NL-14-0702

Joseph M. Farley Nuclear Plant – Units 1 and 2
Supplement to Response for Additional Information Regarding Condensate
Storage Tank Minimum Level License Amendment Request

**Modified Response to Questions 3 and 4 of Request for Additional
Information Dated September 25, 2012**

SNC Calculation SM-SNC335993-001,
“CST AFW Pump Suction – Submergence Analysis,” Version 3.0
(Non-Proprietary)

SUCTION PIPE GEOMETRY AND NOTATION

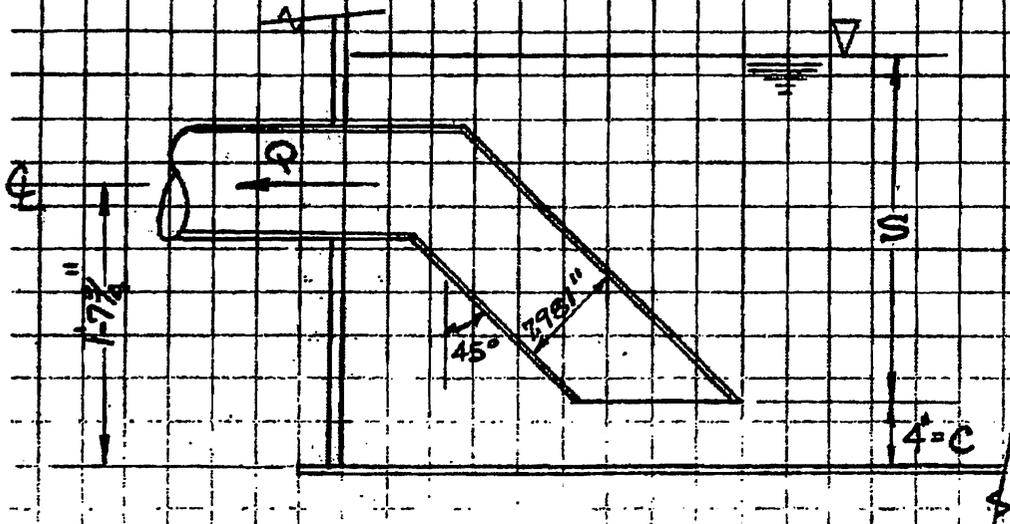
The CST has two 8" AFW suction pipes – one for the TDAFW pump and one for both MDAFW pumps. Both suction pipes open at 4" from the tank's bottom, facing down at a 45 degree angle with the entry to the piping being parallel to the tank bottom. The suction piping centers are approximately 1'-3" apart. The CST has an internal bladder that prevents introduction of air under normal operating conditions.

Based on the inlet of the piping being 4 inches from the bottom of the tank as shown on Attachment 1, the minimum submergence above the tank's bottom shall be 9.78 inches or greater for a flow of 700 gpm.

Figure 5 Definition of submergence for vertically downward and horizontal suction configurations

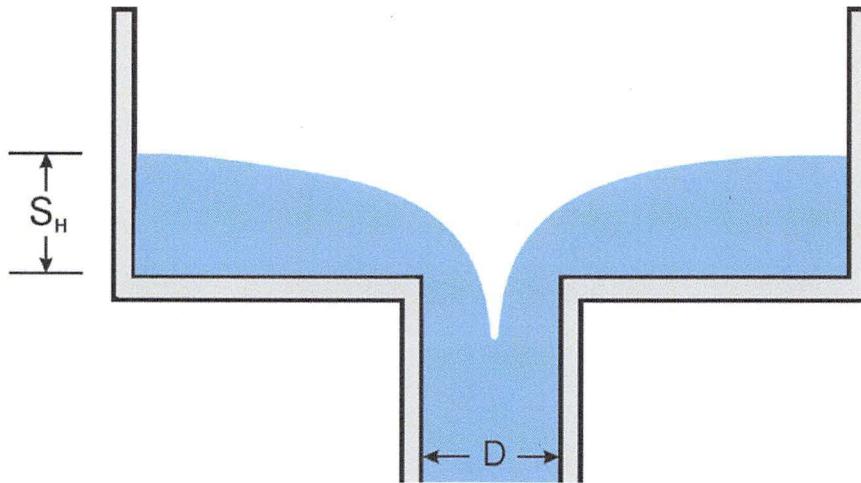
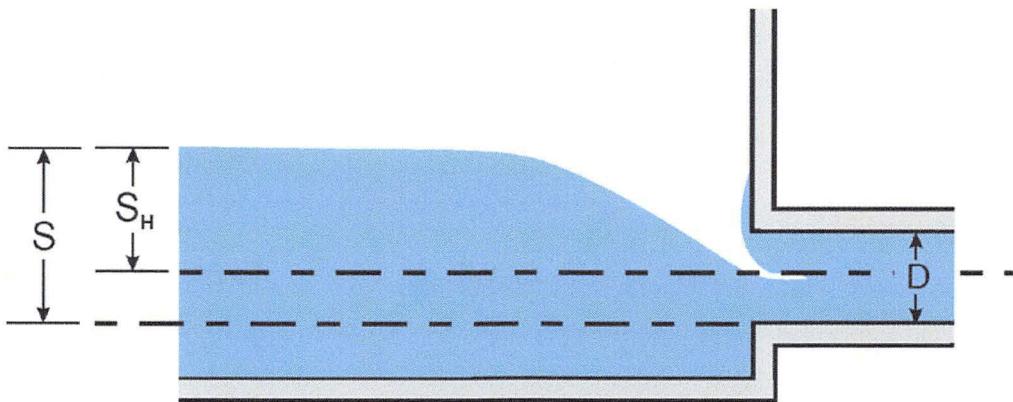
The equation based on the Harleman correlation presented on page 17 of 24 of calculation-note FAI/09-19 defines the submergence as the water height above the horizontal entrance to the vertically downward suction location as shown in Figure 5(a) of this calculation-note. This correlation is given as $S_H/D = 0.75[N_{Fi}]^{0.4}$. Even though the Farley suction nozzle is a 45 degree downward facing nozzle configuration that results in a lesser submergence level, as shown in Figure 6, the Harleman correlation was used to provide a conservative submergence level. Using this vertically downward suction correlation increased the submergence level by a factor of two over the submergence for a 45 degree angle pipe or elbow nozzle facing downward. Thus, this greater submergence level was used in determining the volume component required in the CST sizing calculation for vortex prevention. The submergence level, based on the vertically downward suction configuration, the piping size, and the AFW pumps flow rates, was determined to be 5.78 inches. Since the AFW pump's suction pipes open at 4 inches from the tank's bottom, the submergence level used to determine the CST's volume component to prevent air intrusion and vortex formation is 9.78 inches (using the correlation for the downward-facing elbow gives a smaller value of 7.7 inches).

These results are conservative since the minimum submergence height equation used in this methodology represents a vertically downward suction configuration as shown in Figure 5(a) of Attachment 3. However, the AFW pumps suction piping has a configuration of a downward facing inlet as shown in Attachment 1. The minimum submergence scale model test results described in Attachment 3 for the downward facing inlet yield a lower submergence level than the equation used in this calculation.

Figure 2-1 Re-drawn figure showing the dimensions of the scaled test for D.C. Cook (based on the illustration in (Sanders et al., 2001)).

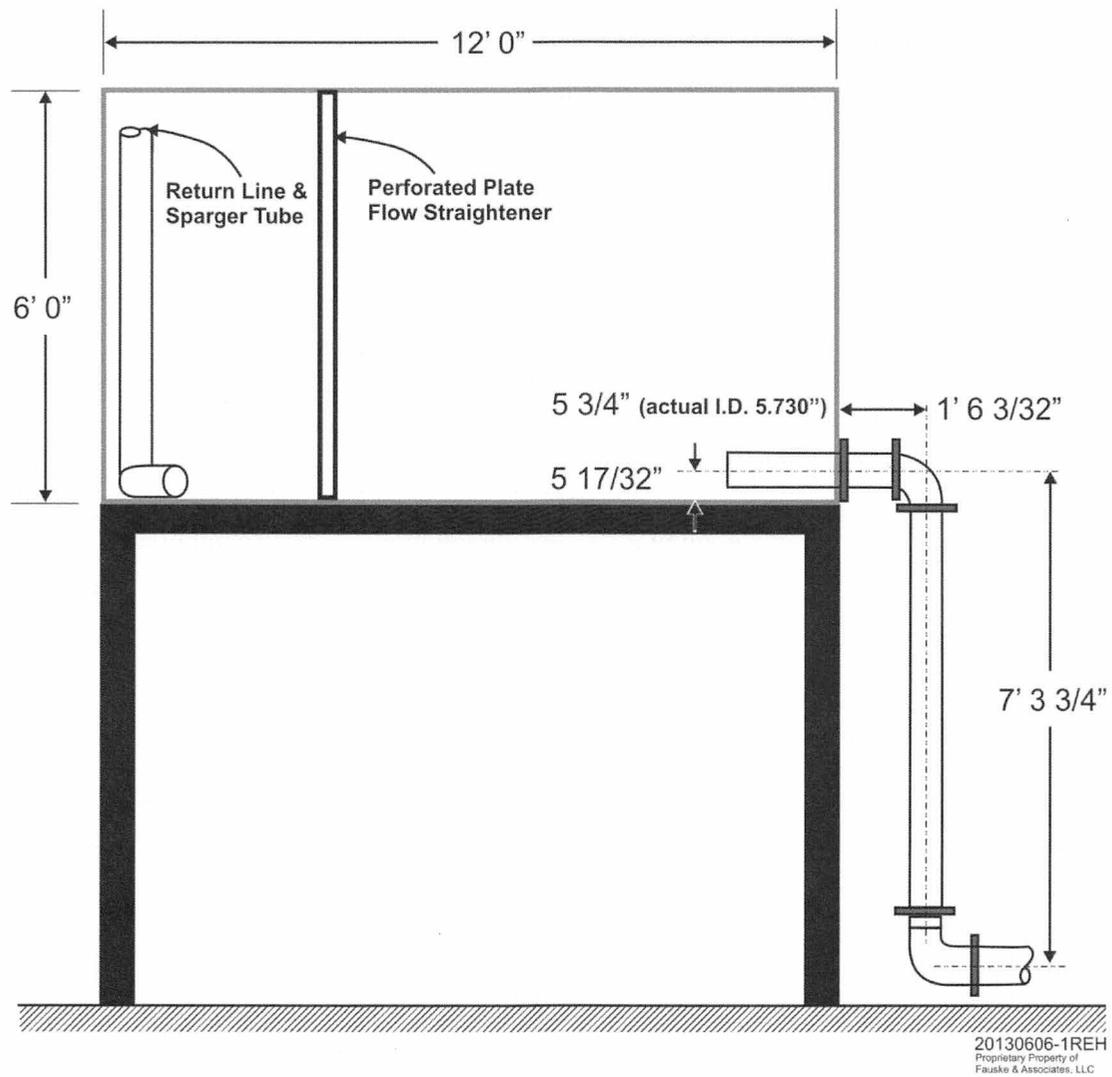
1. Drawing of the plant tank and the plant suction pipe within the tank that provides all relevant dimensions,
2. Drawing of the corresponding test configuration that provides all relevant dimensions,
3. Description of how quantitative air entrainment is determined during testing,
4. Description of conduct of the test that includes any observations, and
5. Summary of the test data such as a plot of critical submergence as a function of Froude number.

The experimental model for D.C. Cook was a 12 foot diameter and 6 feet high tank with a 5.73 inch horizontal suction pipe that was approximately 5.5 inches above the tank floor and approximately 1.75 feet of suction piping inside the tank (Sanders, et al, 2011). See Figure 2-1 that is re-drawn from the figure in the referenced paper which is difficult to read in the original reference.

The scaled tests for D.C. Cook provide insights into whether important rotational flow conditions are generated as a result of the tank geometry, the drain down transient, etc. These results are compared to the Harleman correlation, on page 15 of report (FAI, 2009), where the submergence is increased by one-half of the suction pipe diameter. (The submergence in the D.C. Cook experiments was defined with respect to the inside bottom surface of the suction pipe, as noted in Figure 5b of (FAI, 2009).) The graph in Figure 3 of (FAI, 2009) shows that the Harleman correlation agrees well with the results of the D.C. Cook tests or conservatively bounds the experimental data. Based on the D.C. Cook tests, the FAI report states that the Harleman correlation provides good agreement with the D.C. Cook data for critical submergence characterizing the onset of significant air entrainment.
